DART SERVICE INSTRUCTION

TO AMEND INSTALLATION INSTRUCTIONS D205-523 REV. F, AND INSTRUCTIONS FOR CONTINUED AIRWORTHINESS ICA-D205-523 REV. 1 OR LATER APPROVED REVISIONS

ALTERNATIVE INSTALLATION NTS

FIGURE 1: Location of the D205-523-013B Heli-Rappel Installation

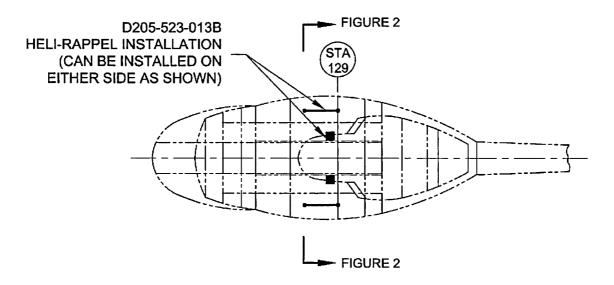
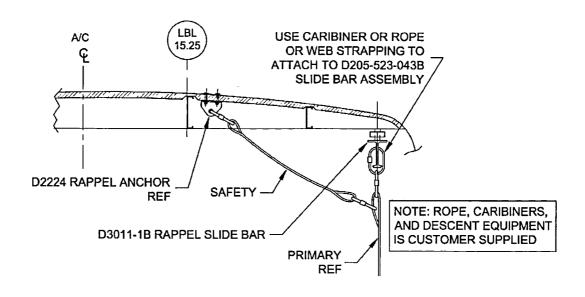
- 2.1 Install D2224 Rappel Anchor per D205-523, Step 1-2.
- 2.2 Position the D3011-1B Rappel Slide Bar per Figure 1 and 2 of this DSI.

- 2.3 Mark and transfer the Fwd/Aft center of the mounting studs onto the each upper flat surface of the Slide Bar. Note: Slide bar must be positioned to maintain a minimum edge distance of 0.580" for each hole (ie. the center of each hole must be no closer than 0.580" of the surface edge).

FIGURE 3: Installation of D205-523-043B Slide Bar Assembly (View Looking Inboard)

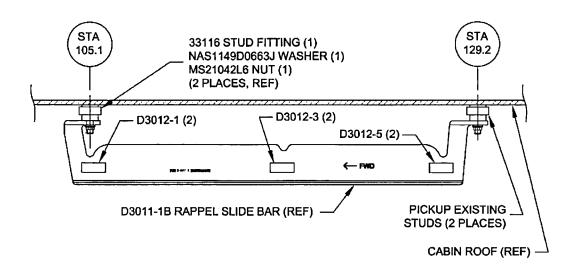
- 2.5 Touch up holes with Alodine 1200/1201 per MIL-C-5541 and prime/paint per Aircraft Maintenace Manual.
- 2.6 Install the D205-523-043B Rappel Slide Bar Assembly, picking up on existing studs from Step 2.2 as shown in Figure 3 of this DSI.
